Project 1680

Subject: **SUPPLEMENTAL REPORT No. 2**
23401 Civic Center Way,
Malibu, California

GEOTECHNICAL REVIEW SHEET

<u>Project Information</u>			
Date:	May 27, 2010	Review Log #:	3142
Site Address:	23401 Civic Center Way	Planning #:	CDP 10-022
Lot/Tract/PM #:	n/a	BPC/GPC #:	
Applicant/Contact:	Marny Randall, marnyrandall@verizon.net	Planner:	Bonnie Blue
Contact Phone #:	310-395-2615	Fax #:	310-395-2368
Project Type:	Revised Project-Whole Foods Shopping Center

Description:
 Geologic Map
 Issued For:
 Whole Foods

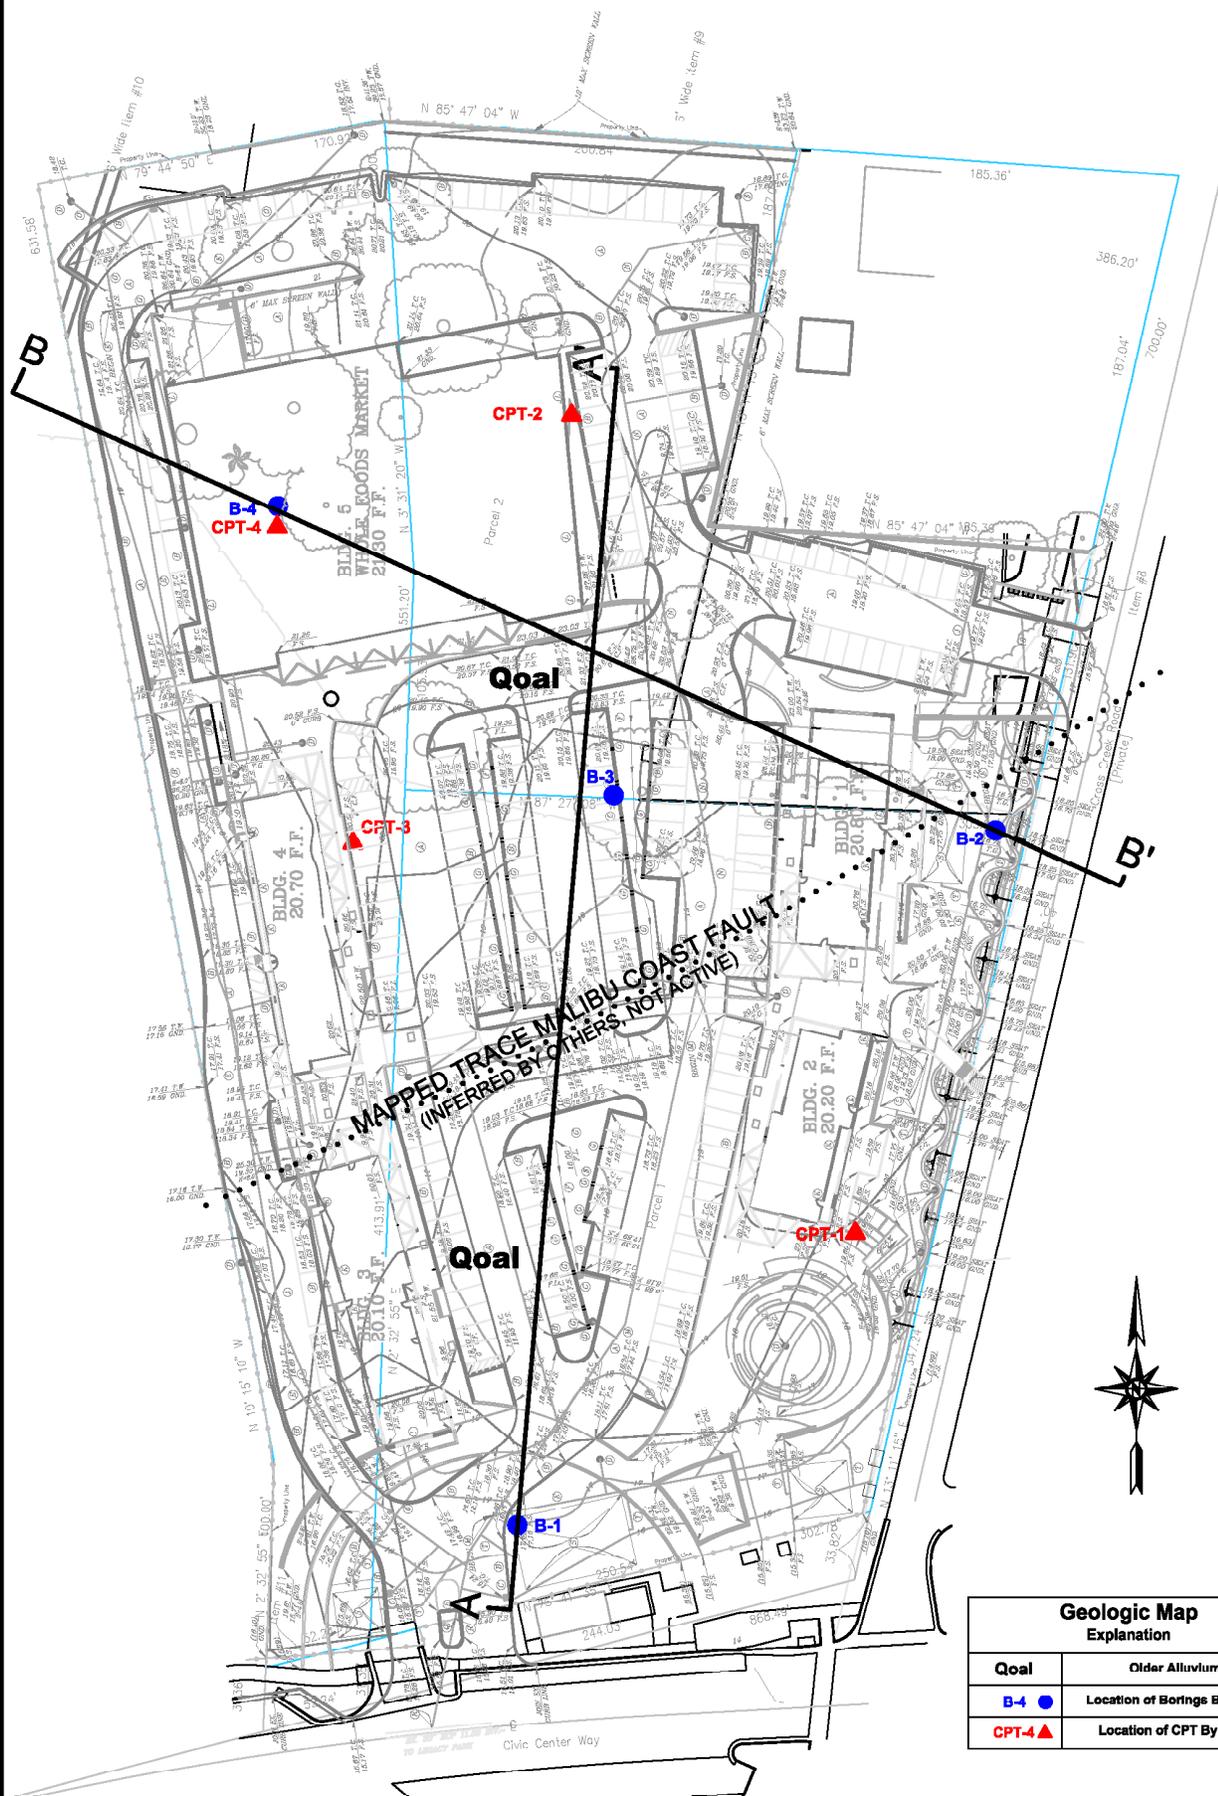
1. The Project Geotechnical Consultant provides an updated geologic map and cross-sections that depict the currently proposed grades and development. Please clearly depict the proposed removals under the site. Additional recommendations shall be provided, as necessary, regarding the revised development plans. The Project Geotechnical Consultant provides no discussions regarding the revisions to the development.

2. Please show the seismic trenches on the Geologic Map. Is there adequate coverage for the currently proposed development? Besides the findings in the seismic trenches, what additional evidence supports the Project Geotechnical Consultant's conclusion that, "...no known active fault is anticipated to daylight beneath the limits of the proposed structure."?

- Item #1: Attached is an updated map based on the currently proposed development. The plan essentially depicts the site be elevated from the existing grade up to about four (4) feet from the current grade.
- Item #2: A non-active fault is mapped by the U.S. Geologic Survey (1980) and Treiman, (1994) near the central portion of the site. On August 16, 2007, the fault zone near the east side of Malibu Bluff Park was removed from the State of California Earthquake Fault Zone map by the California Geologic Survey.

The previous seismic trenching on the site in the late 1990's (for a previous development) was logged by a licensed geologist. No positive evidence of active faulting was exhibited within these seismic trenches or test pits. Review of aerial photographs from 1928 and 1952 lack geomorphic evidence and/or photo-lineaments to suggest active faulting on the site. The site is not mapped within an active fault zone. Therefore, no known active fault is anticipated to daylight on the site.
